DEVELOPMENT REVIEW COMMITTEE (DRC) COMMENT REPORT

PROJECT NAME: Fairfield Inn & Townplaces Suites

CASE NUMBER: UDP-S21038

REQUEST: Site Plan Level III Review: 172-Room Hotel with Parking Reduction

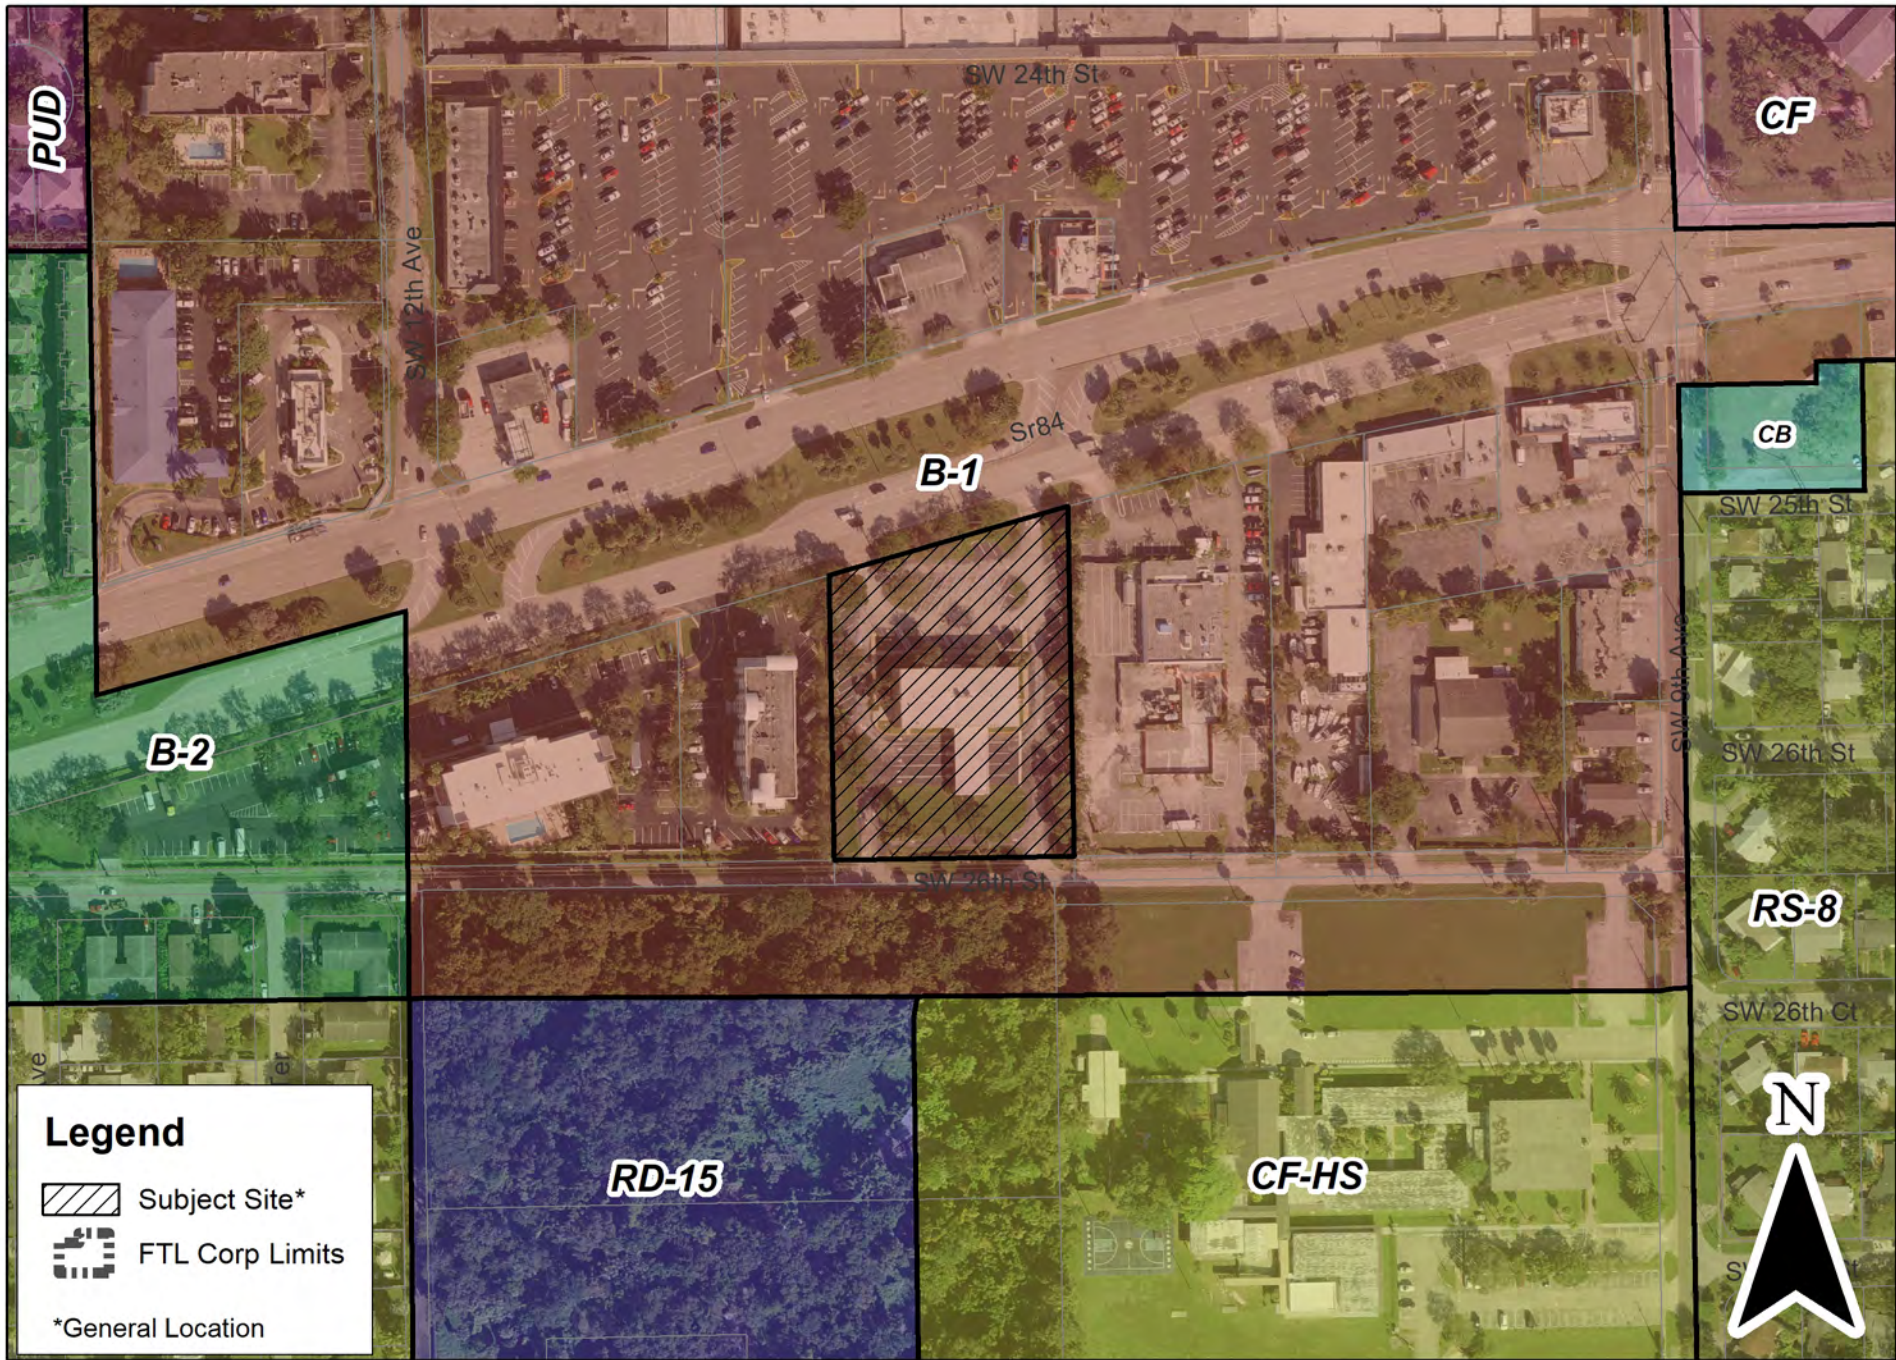
10. Pursuant ULDR Section 47-23.9 Interdistrict Corridor Requirements, enhanced pedestrian elements should be provided. Consider more activation of ground floor uses (such as offices, lobby area, amenities, etc.) along State Road 84 to provide a more amicable pedestrian environment. Current floor plans show studios at the ground level facing State Road 84. See attached photos below for reference.
